**Report ID:** 2014-00626

**Title:** Appeal of Lot Split and New Alley Dwelling Unit (Z13-138) [Noticed 08/22/2014]

**Location:** 2515 D Street, District 4

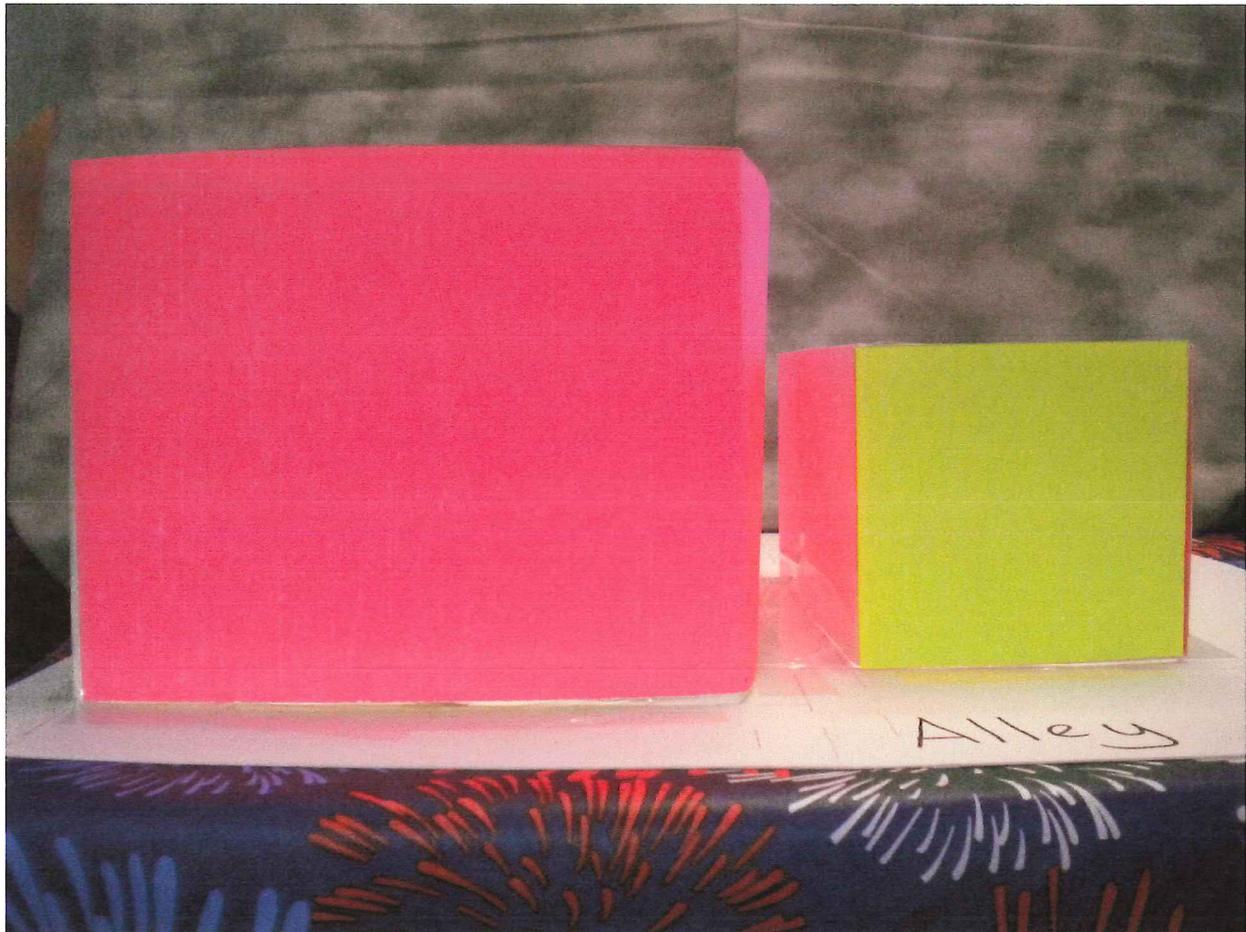
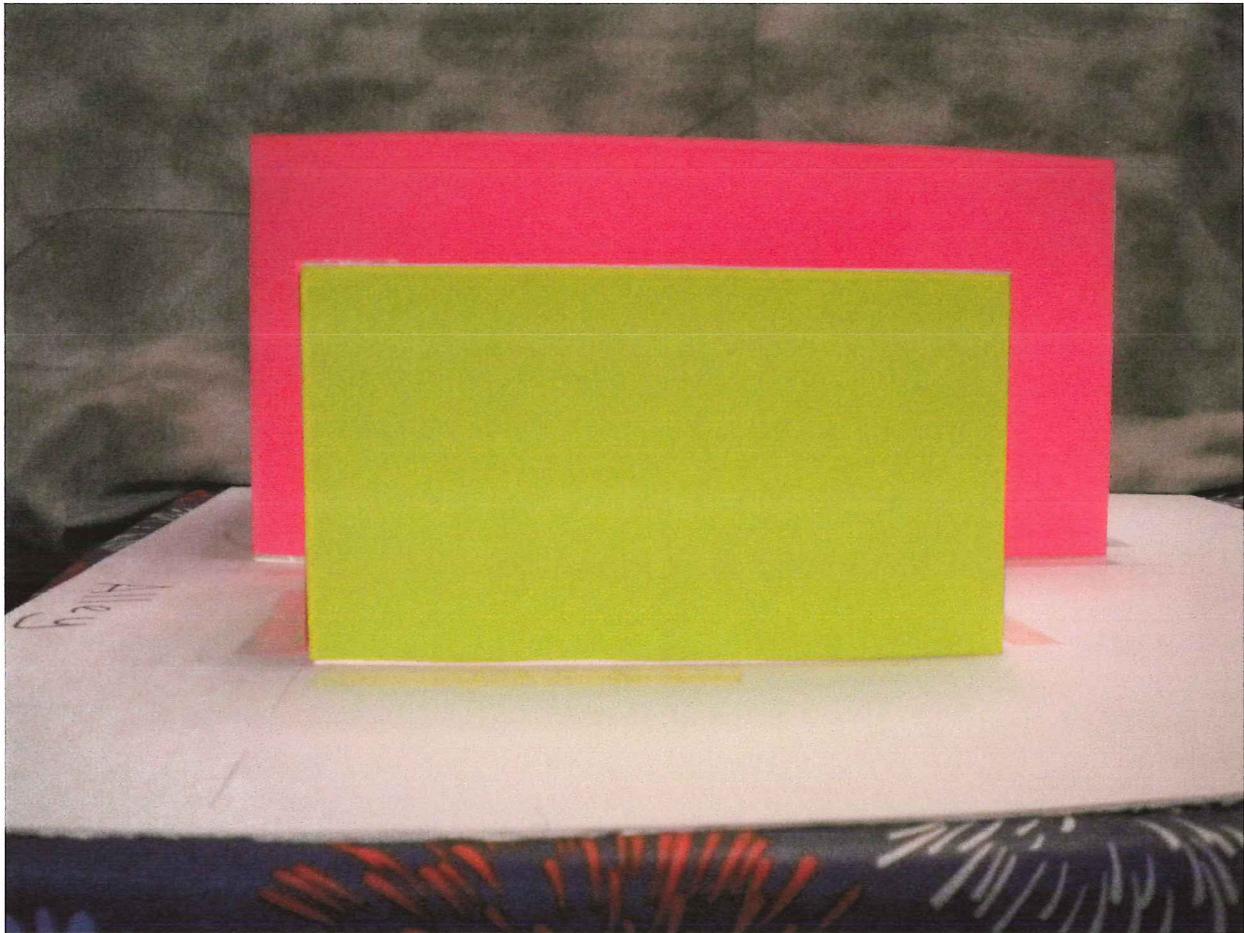
The proposed new structure at 2515 D Street fails to maintain access to light and air circulation. The new structure would tower over the current home at 2509 D Street not only in height but also in depth also impeding on the home at 2511 D Street. The view from the second story of the new structure would invade the privacy of the homes at 2509, 2511, and 2517 D Street. The effect would be 2509 D Street would only see a

massive wall. The wall would radiate heat. The new structure would shadow the existing home at 2509 D Street preventing natural sunlight from entering the residence. The residence at 2509 currently enjoys morning sunlight which comes into the main living areas of the home. The new structure would peer into the big open space between the front and back houses at 2509 and 2511 D Street. The second story window would invade the privacy of the current residents at 2509, 2511, 2515, and 2517 D Street.

We have prepared this layout to help illustrate the impact it will have especially to 2509 D Street. The scale is  $\frac{1}{4}$  inch equals a foot. It does not demonstrate what the roof lines are like but it does show the approximate height of both buildings. The cottage at 2509 D Street is 17 feet high and 2515 D Street is 25 feet high.

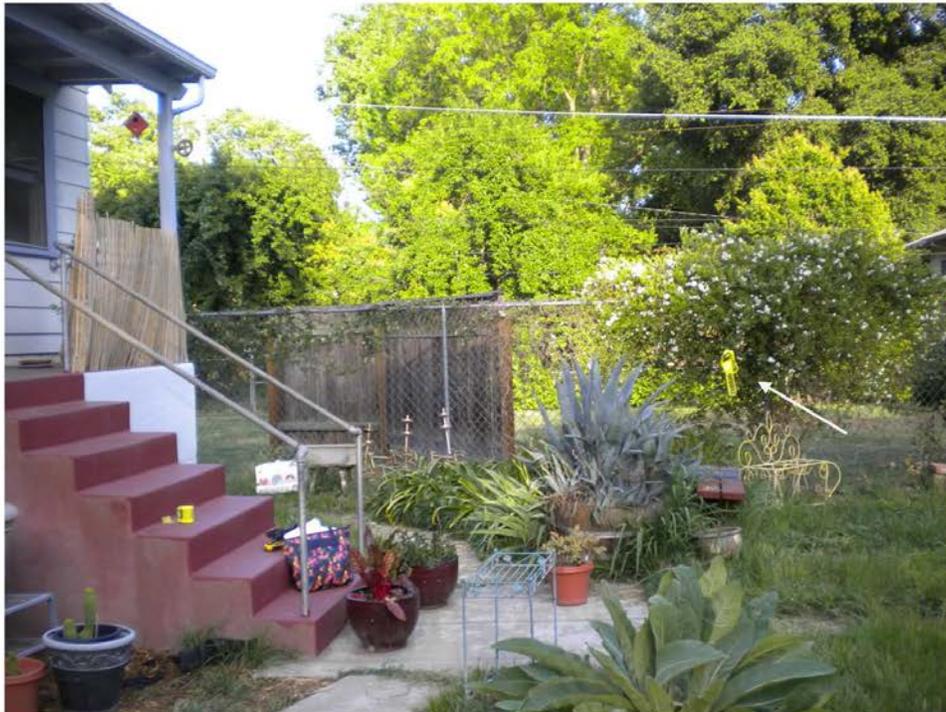
See picture below which shows where the rear of the proposed residence at 2515 D Street would be. The yellow tape is approximately 66 feet from the alley fence.

The effect would be 2509 D Street would only see a massive wall. Natural sunlight which is currently present would be blocked from coming into the house. Further the building because of its height, width and would closeness would prevent any air circulation. In effect this new massive structure would radiate heat into 2509 D Street.

The proposed new building would prevent the natural light (which the house currently enjoys) from coming into the main living areas of the house.
